HOLTEC INTERNATIONAL

HI-STORM 100 CERTIFICATE OF COMPLIANCE 72-1014

CERTIFICATE AMENDMENT REQUEST 1014-1

SUMMARY OF PROPOSED HI-STORM 100 CHANGES¹

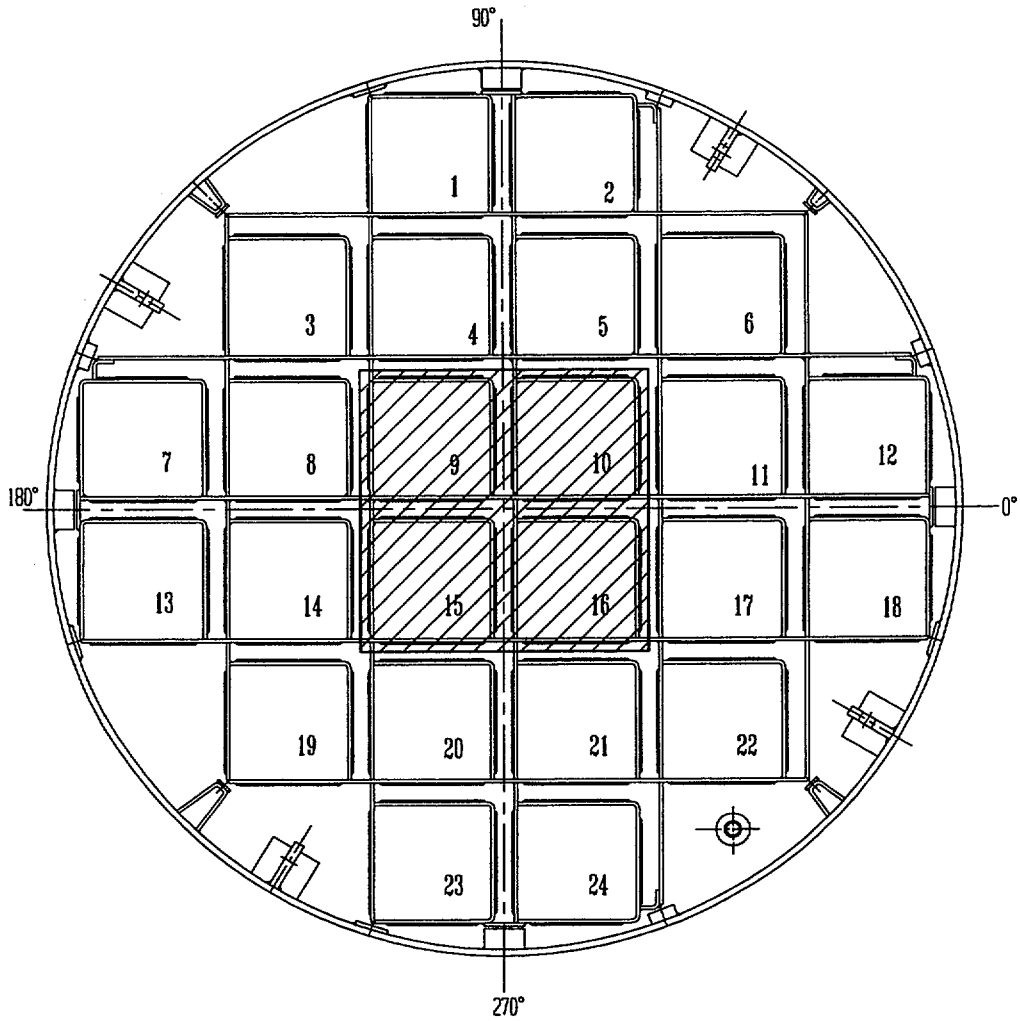
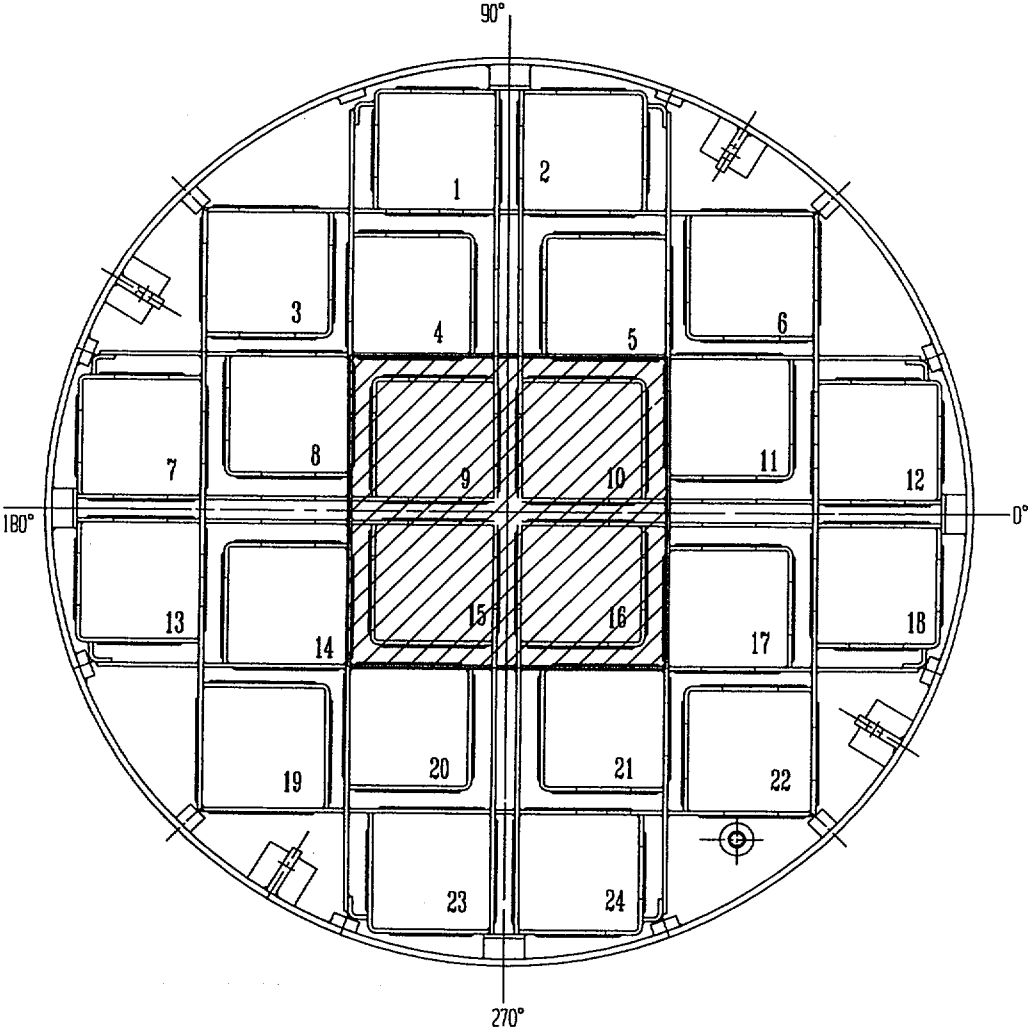
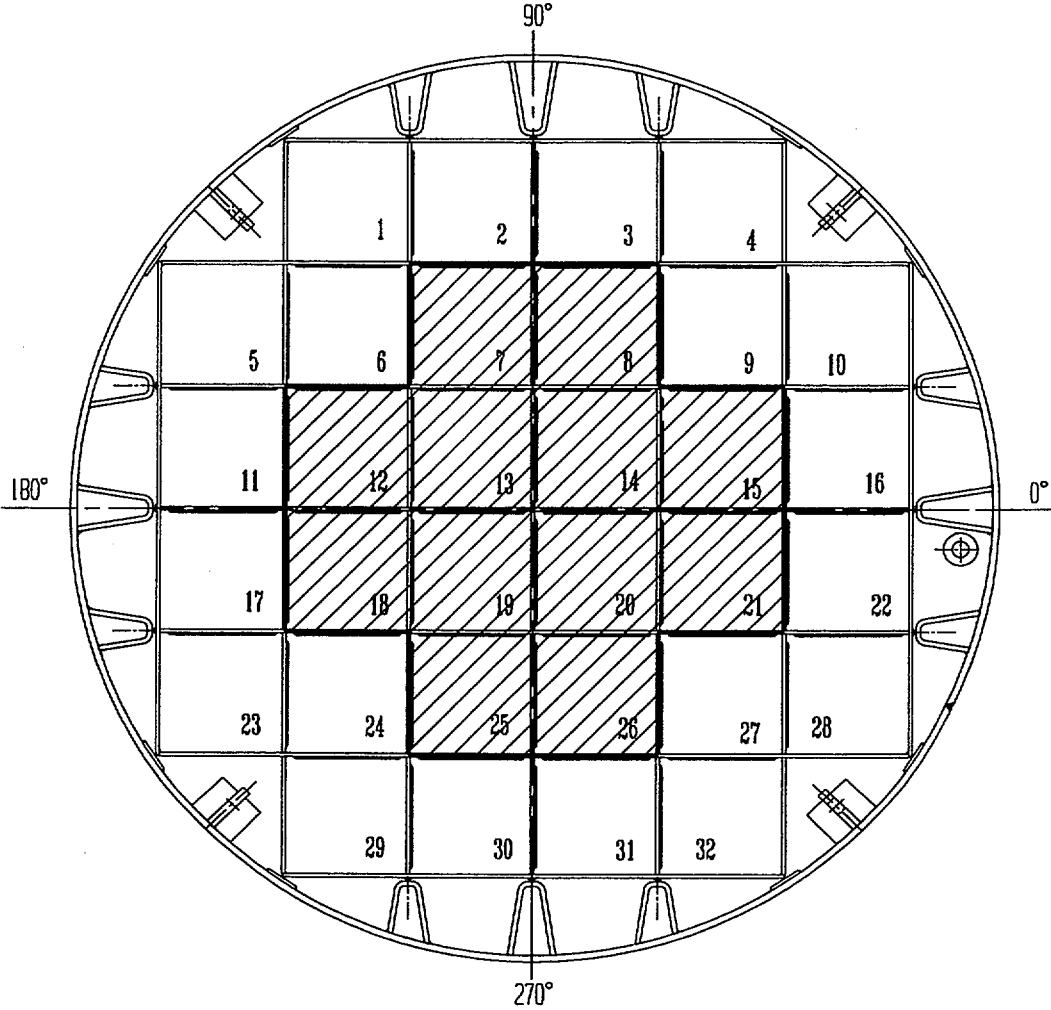
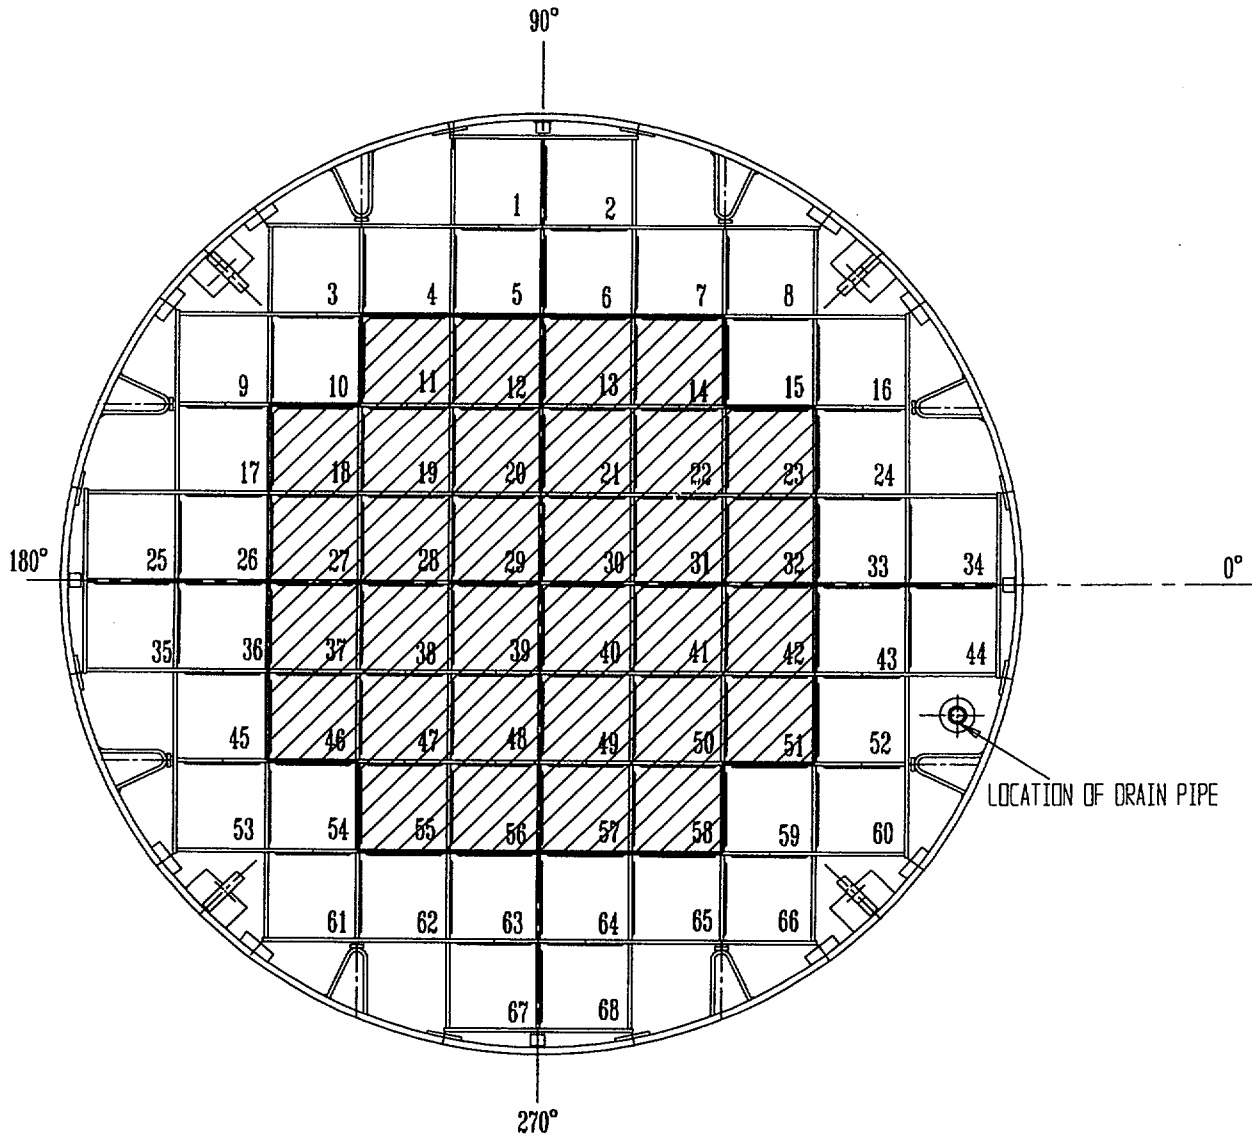
- b. New Subsection 2.1.3 and Figures 2.1-1 through 2.1-4 are added to introduce regionalized fuel loading as an option. Specific cooling time, burnup, and decay heat limits for regionalized fuel loading are specified in Tables 2.1-6 and 2.1-7 in the Approved Contents section of Appendix B to the CoC.

- a. Clarification to distinguish between uniform fuel loading and regionalized fuel loading and to clarify that regionalized loading meets the intent of preferential fuel loading.
- b. Regionalized fuel loading, in accordance with Figures 2.1-1 through 2.1-4 and Tables 2.1-6 and 2.1-7, as applicable, allows users to load relatively higher heat emitting fuel assemblies than would otherwise be allowed using uniform fuel loading.
